NOTICE OF DENIAL

RE: Application Number 20-6894; 1991 Chicago; Boston Edison Historic District

CERTIFICATE OF APPROPRIATENESS

4 PORCH SECTION
A1.1 1 1/2"=1'-0" 0 1'-0"

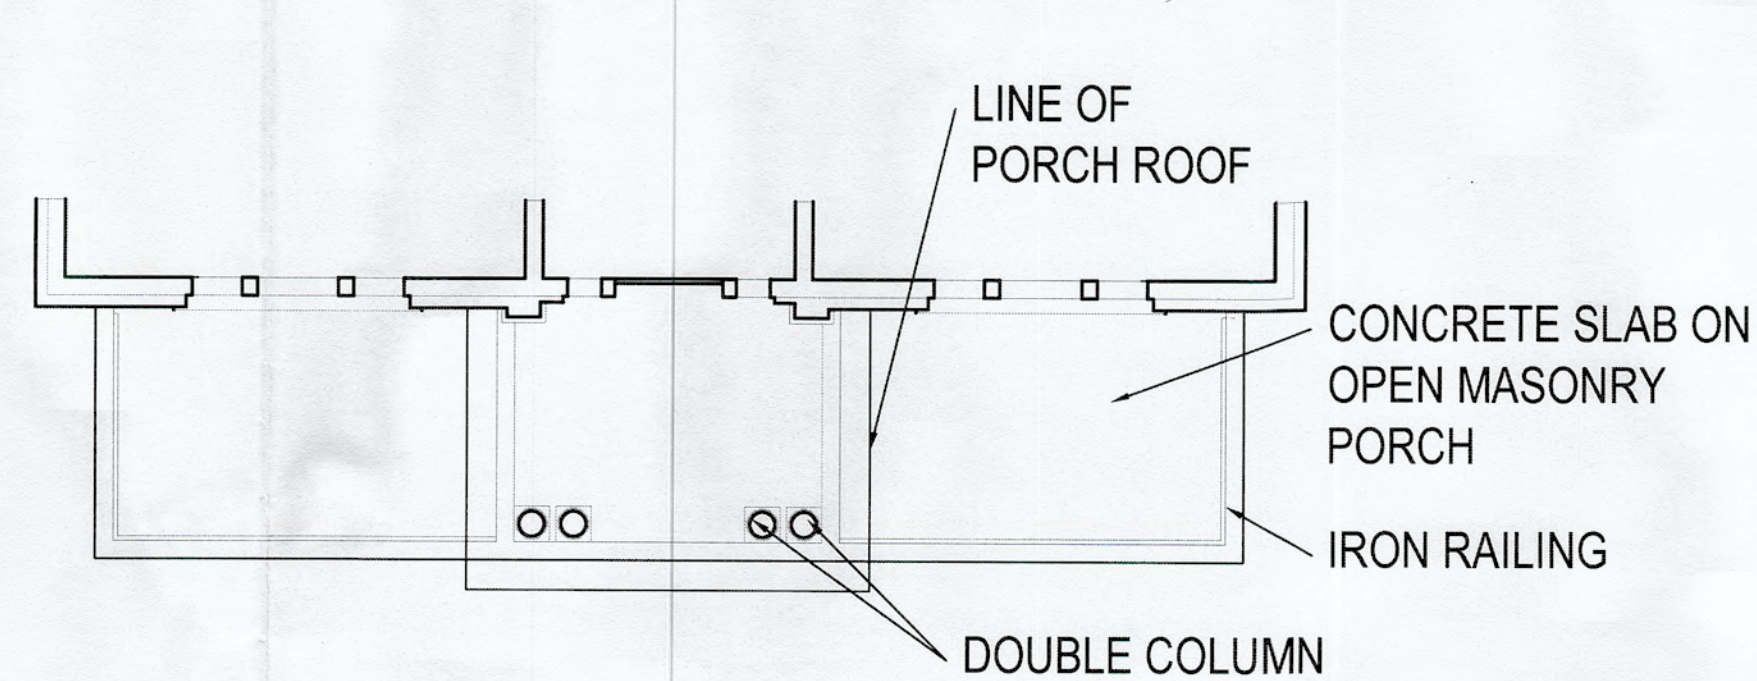
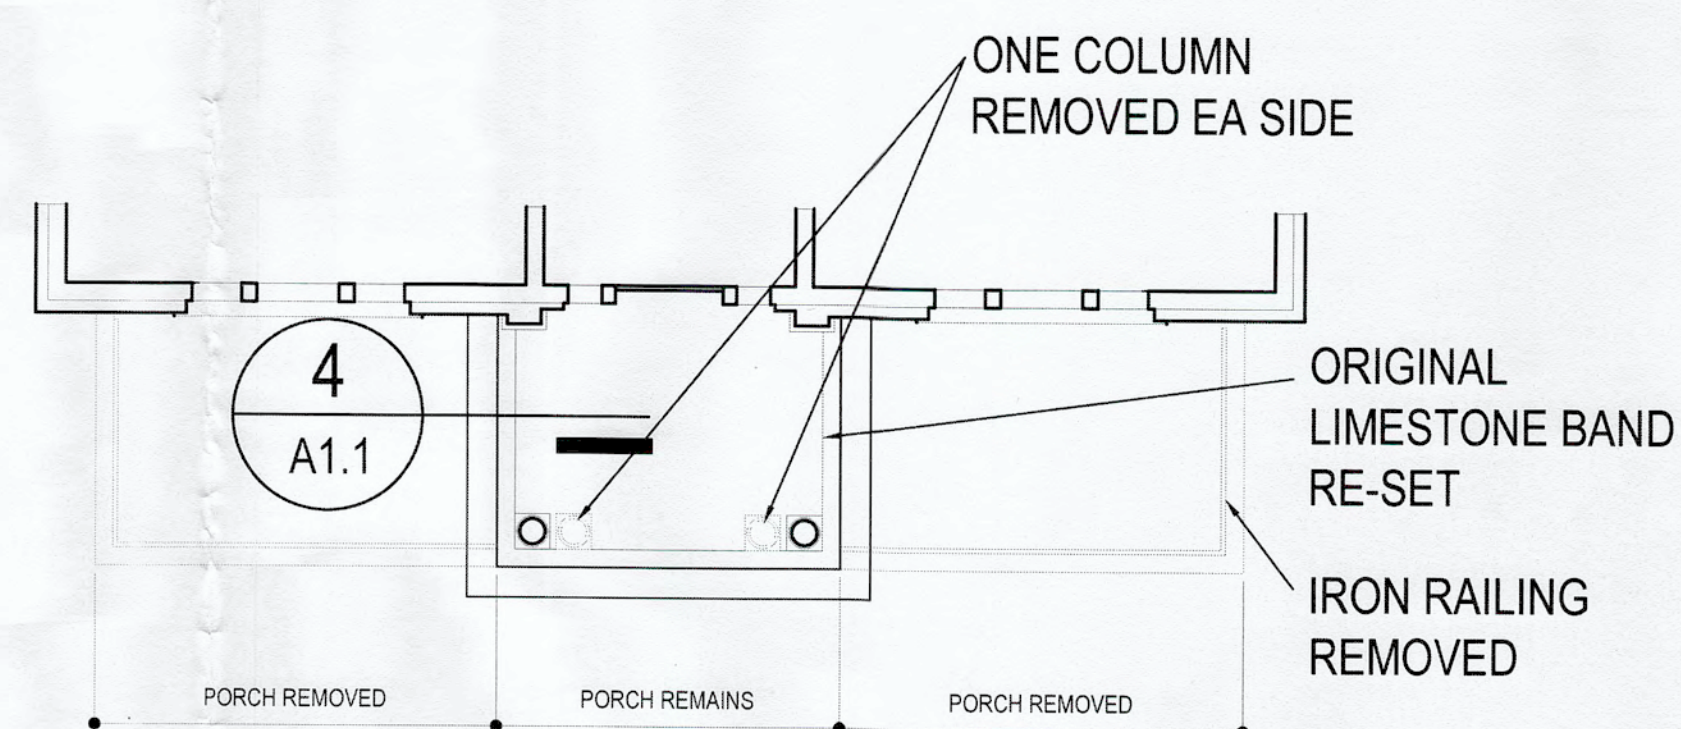
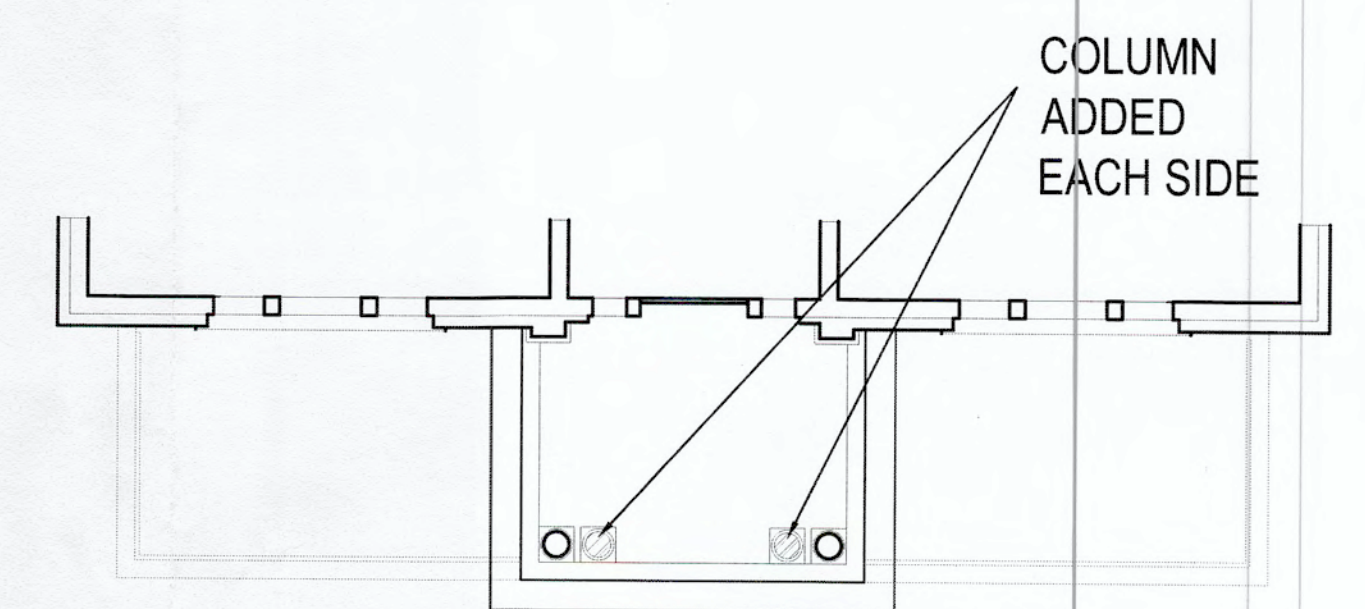
- The removal of porch wings, columns and railings and front elevation wall treatment without permit and/or approval of the Historic District Commission.

1) Wings of porch removed. The wings were collapsing due to failing footings (See attached photo). The wings could not have been repaired. They would have had to be completely re-built. In order for us to do so we would have had to dig out the old footings and pour new ones and re-build from that point. Rebuilding the wings would have added \$20,000 to the cost of the porch rebuild. This would not have made financial sense considering the value of the home. The main porch's footings were in good shape so we were able to just rebuild the brick work etc. for the center porch. In respect to the old footings, we dug them out and removed to accommodate installation of the new landscaping and grading from the exterior walls of the house. We also used as much of the original porch materials as possible in the re-build which is evident in the photos.

2) Railings on wings of porch removed. The railing was corroded and damaged, but intact, on the left wing but none attached to the right. The vintage of the railing was undetermined.

3) Columns reduced from 4 to 2. The two interior columns were rotted out and could not be salvaged. The exterior columns were able to be salvaged and re-built/repared.

1. Rebuild porch to its original dimensions using matching materials, including wings with iron railings to match original, and including wood columns to match originals.
2. Correction work must receive a COA in order to receive a Building Permit, prior to beginning work.
3. Correction should be completed by June 2021
